THIS SERVICE BULLETIN SUPERSEDES REV. A

SUBJECT: Replacement of Dukes Astronautics Fuel Pumps, Part No. 4140-00-19, 4140-00-19A, 4140-00-21, and 4140-00-21A

MODELS AFFECTED: M20E (Super 21), Serial No. 101 thru 850
M20C (Mark 21), Serial No. 2623 thru 2737, 2739 thru 3198
M20D (Master), Serial No. 201 thru 260

FIGURE 1

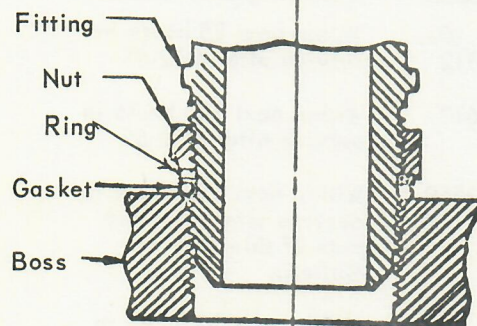
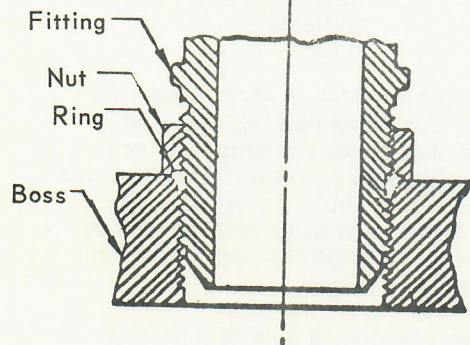
Coat male threads of fitting, ring and gasket, sparingly with petrolatum, Spec. AN-P-51 (vaseline), or hydraulic fluid and assemble as shown. Work the ring into the counterbore of the nut; then turn the nut down until the gasket is pushed firmly against the lower threaded section of the fitting.

Install ring with smooth (hair) side toward the O ring

Install the fitting into the boss and, at the same time, keep the nut turning with the fitting until the gasket contacts the boss. This point can be determined by a sudden increase in torque. With the fitting in this position, put a wrench on the nut to prevent its turning and, at the same time, turn the fitting in $1\frac{1}{2}$ turns. Position fitting by turning in not more than one additional turn.

Hold the fitting and turn the nut down tightly against the boss. Slight extrusion of the ring is not detrimental.

2. Remove the fittings from this old pump and install them in the new pump as shown in Figure 1.
3. Re-install new pump.
